## ADDENDUM NO. 1

First Community Branch Bank  
Brookland, AR

Project #1654

February 18, 2020

**ADD 3.1**

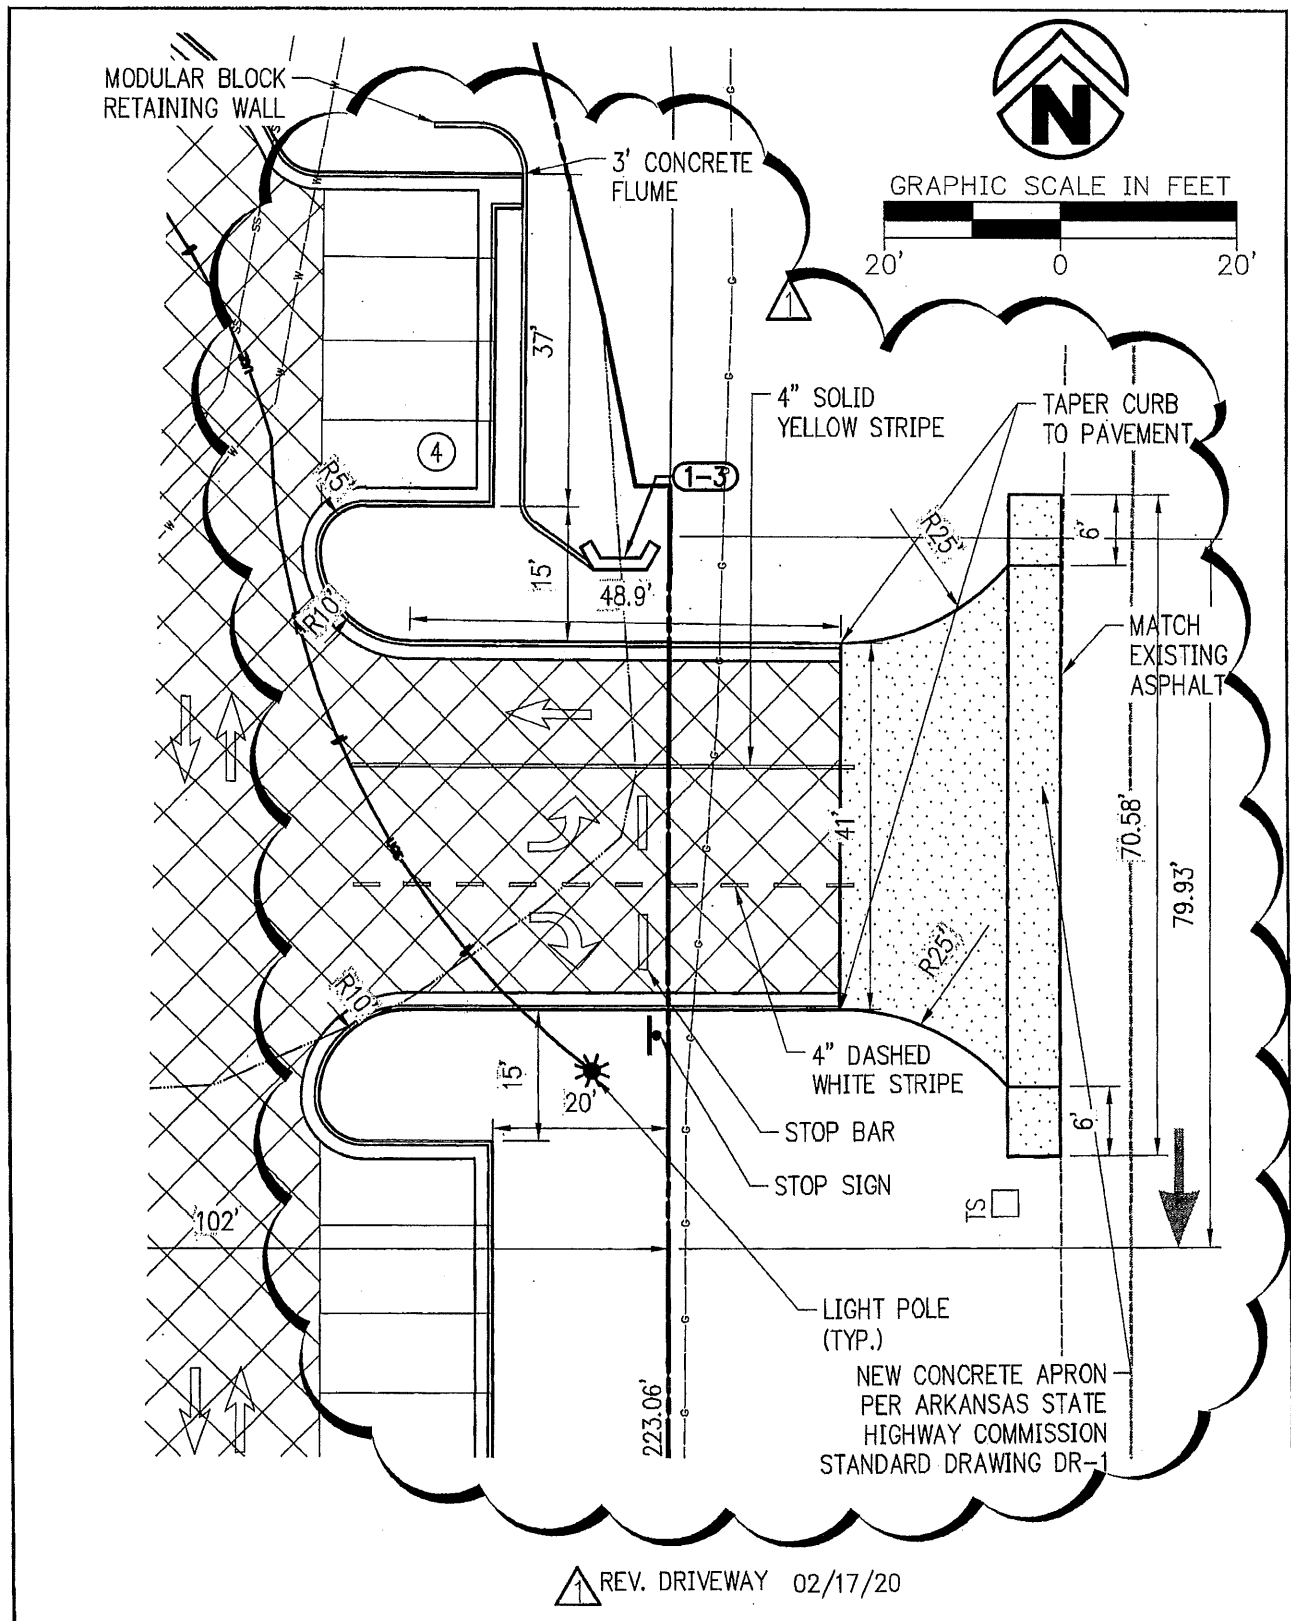
#### B. Sheets C1.01, C1.02, C1.03: Refer to attached new Drawings ADD1.1, ADD1.2, and ADD1.3, for revised Hwy. 49 driveway layout.

△ REV. DRIVEWAY 02/17/20

**ADD 3.2**

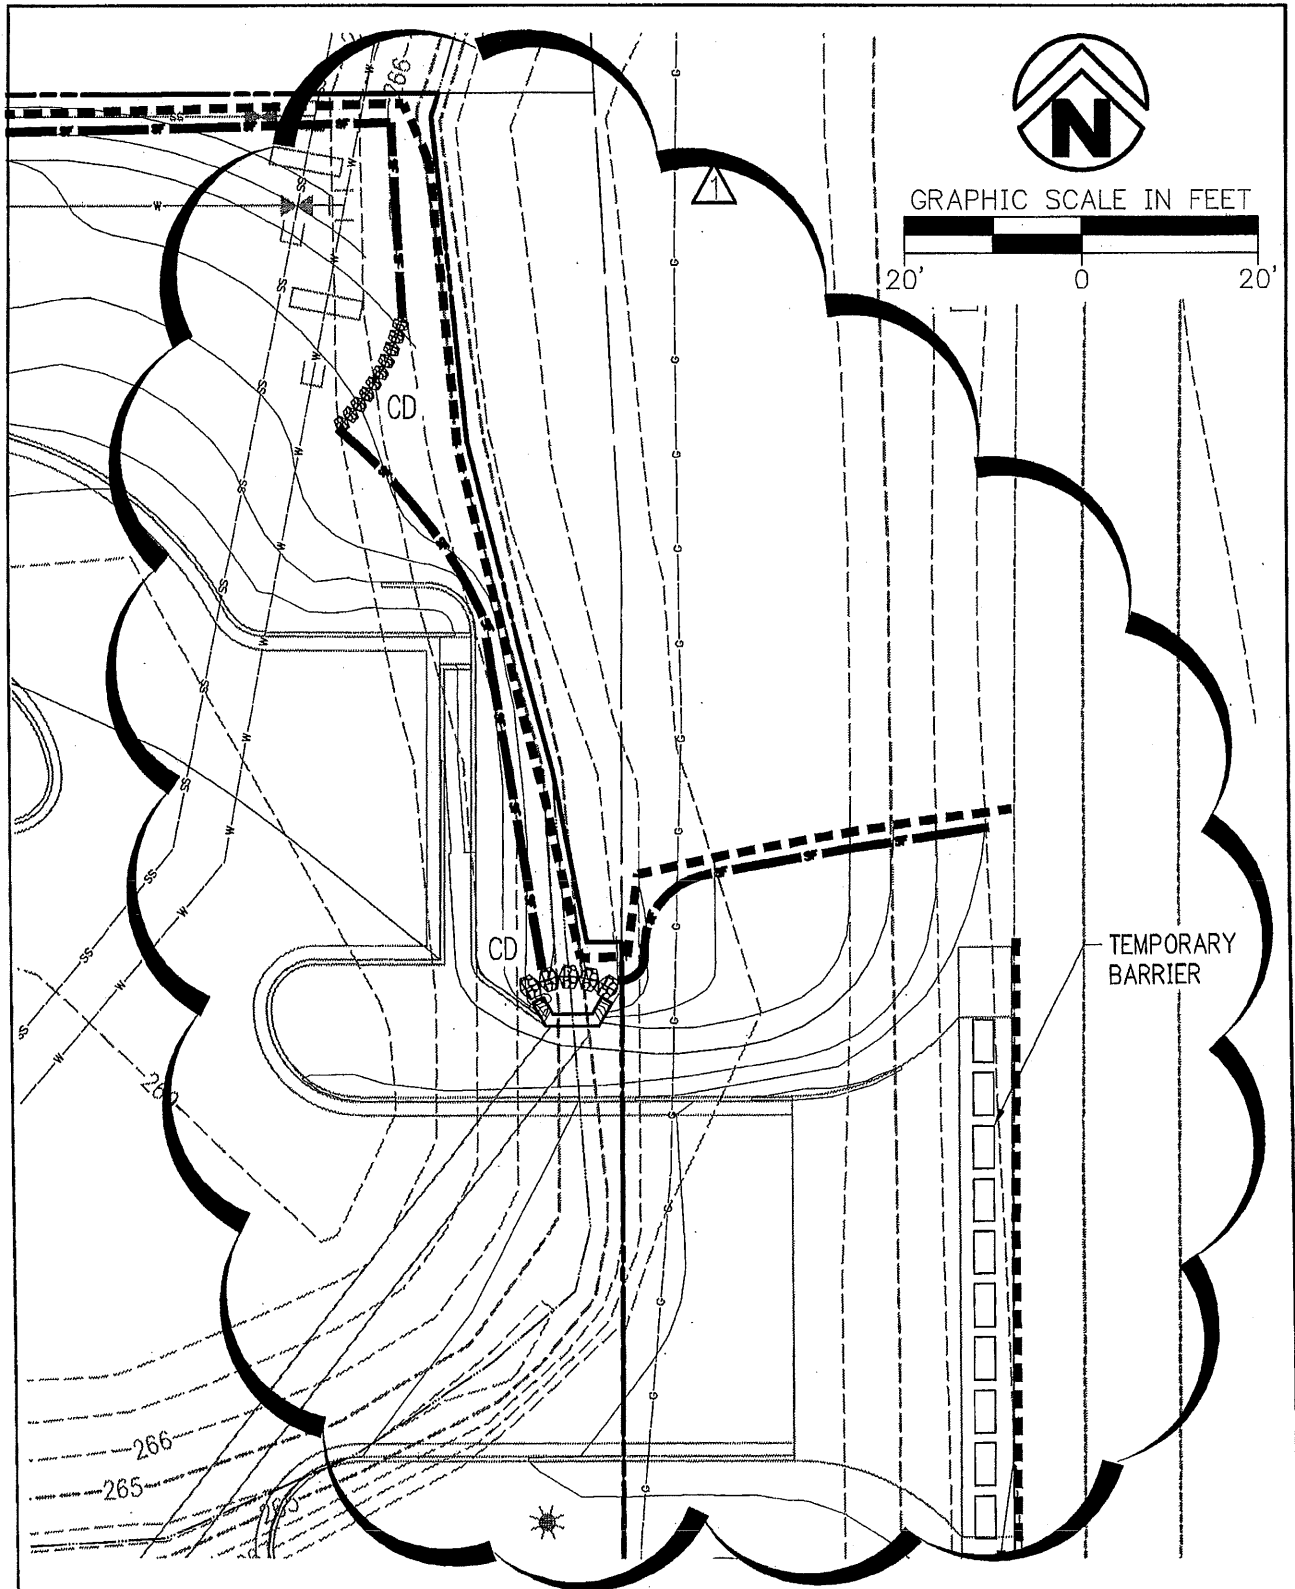
REV. DRIVEWAY 02/17/20
